19 December 2019

Our Ref: 190483

**BUILDING CODE OF AUSTRALIA ASSESSMENT
30 FAIRLIGHT STREET, FAIRLIGHT**

Figure 1 - Proposed Metal cladding

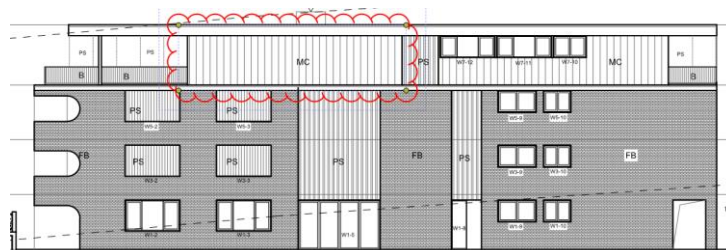
- 4.2. Internal loadbearing walls must be concrete or masonry.
- 4.3. Lightweight fire resisting construction is to comply with BCA C1.8.
- 4.4. The following building elements and their components are required to be non-combustible as required by C1.9 of the BCA:
 - a. External walls and common walls, including all components incorporated in them including the facade covering, framing and insulation.
 - b. The proposed metal cladding must be non-combustible when tested to AS1530.1-1994. Details demonstrating compliance are to be provided at the construction certificate stage of the development.

Figure 2 - Spandrel separation

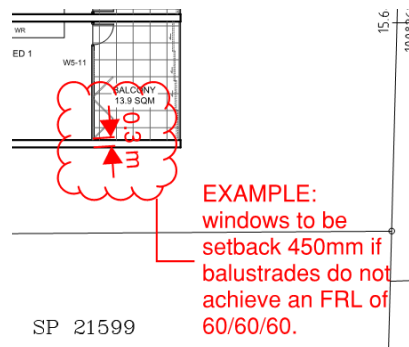
- 4.7. Vertical separation of openings in the external wall are required to comply with C2.6 of the BCA. Spandrels are generally provided where required however the glazing of the Northern and Southern openings are located less than 450mm from the edge of the balcony providing the horizontal spandrel from the openings beneath (example shown in figure 2 below) and does not comply. The windows are required to be set back 450mm from the edge of the building or the balcony balustrades would need to form the vertical spandrel and achieve an FRL of 60/60/60.

Figure 3 - Exposure to allotment boundary

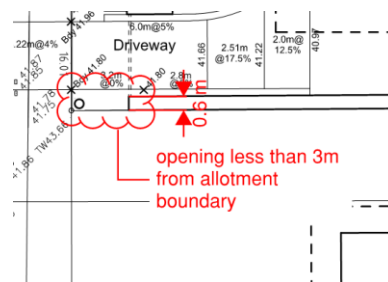
- 4.8. The eastern wall of the basement carpark does not extend the full width of the basement and creates an opening at the driveway entry which requires protection under C3.2 of the BCA as its located less than 3m from the allotment boundary as indicated below. The opening is required to be protected in accordance with C3.4 of the BCA, the wall extended to provide compliant fire separation or the opening justified via a fire engineered **performance solution**.

Figure 4 - Lift within fire stair

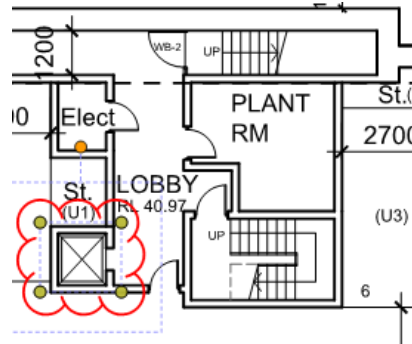
- 4.9. The openings to the required fire isolated lift are required to be protected with -/60/- fire doors in accordance with C3.10 of the BCA.
- 4.10. Stairways and lifts are not permitted to be located within the same shaft under the requirements of C2.11. The lift is currently accessed and connected directly within the fire isolated stair/ shaft as the fire stair and the required fire isolated passageway required to connect the stairway passageway on the basement level outlined in figure 3 and does not comply. The design is required to be addressed via a fire engineered **performance solution**.

Figure 5

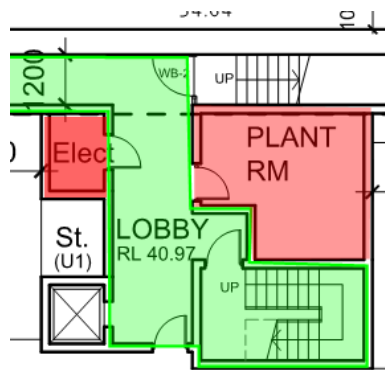
- 4.11. Doors to the central fire isolated stair are required to be self-closing -/60/30 fire doors as required by C3.8 of the BCA.
- 4.12. The plant room and electrical rooms on the basement are required to be separated from the fire stair / passageway with construction achieving an FRL of 90/90/90 with doorways protected with -/60/30 self-closing fire doors. Also refer to D1.7 below.

Figure 6

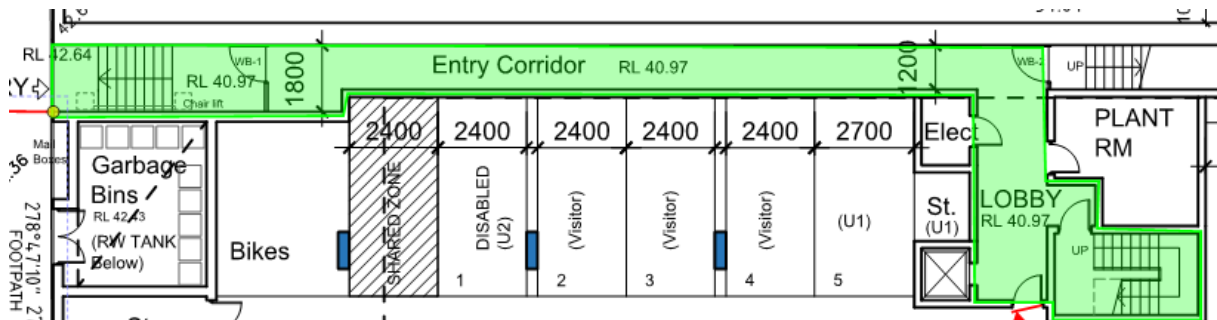
- 4.13. The required fire isolated passageway connecting the central fire stair and the street is only permitted to be penetrated by limited services under the requirements of C3.9 and D2.7 of the BCA. The passageway also has strict combustibility requirements for all floor, wall and ceiling linings and C1.10 of the BCA. The proposed entry to the residential building is doubling as the fire isolated passageway and will not achieve strict compliance, for example, the proposed chair lift is not a service permitted within the fire stair / passageway. The proposed configuration is required to be addressed via a fire engineered **performance solution**.

Figure 7

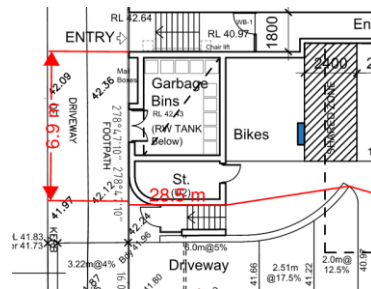
- 5.1. The number of exits provided complies.
- 5.2. The central stairway connects 5 storeys and is required to be fire-isolated under the requirement is D1.3 of the BCA. The stairway is capable of complying however the passageway connecting the stair contains a number of non-compliances which will require a performance solution (refer to above and below as applicable).
- 5.3. The discharge of alternative exits on the carpark discharge are located less than 9m apart and does not comply with D1.5 of the BCA as indicated below. Design modification is required or a fire engineered **performance solution** would be required.

Figure 8 – Fire stair discharge

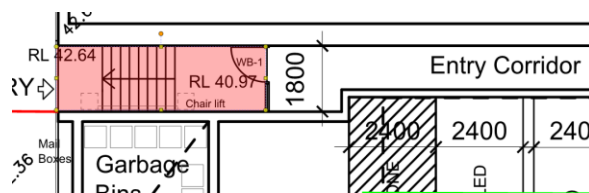
- 5.6. The discharge of fire isolated exits / passageways is required to discharge directly to open space or within an area that's located less than 6m from open space with a floor to ceiling height of not less than 3m and the area is open for not less than 1/3 of its perimeter under D1.7 of the BCA. The proposed fire stair / passageway discharges into the entry alcove which is not open for 1/3 of its perimeter and does not achieve a floor to ceiling height of 3m and is required to be justified by a fire engineered **performance solution**.

Figure 9

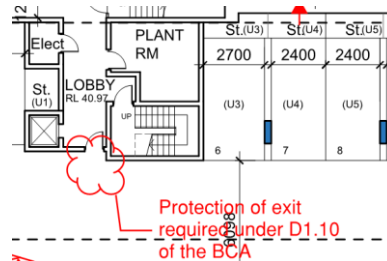
- 5.7. Access to an exit must have suitable barriers to prevent vehicles from blocking the exit to achieve compliance with D1.10 of the BCA. Access to the basement fire stair needs to be

protected with bollards or the like to achieve compliance with D1.10 as illustrated below in figure 9. Details are to be included within the Construction Certificate documentation.

Figure 10 – Example of door swing located less than 1.2 from pan

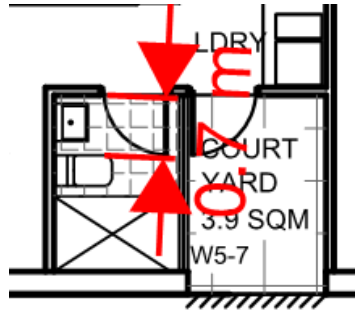
- 7.9. Floor wastes are required to all bathrooms and laundries as required by BCA F1.11.
- 7.10. Glazed assemblies are to comply with BCA F1.13 & AS 2047-2014 Amdt 1 &2 for the resistance of water penetration.
- 7.11. Where sanitary compartment doors swing into the sanitary compartment room and the hinge side of the door is less than 1.2 m from the WC pan, lift off hinges are required to the door (BCA F2.5(b)).
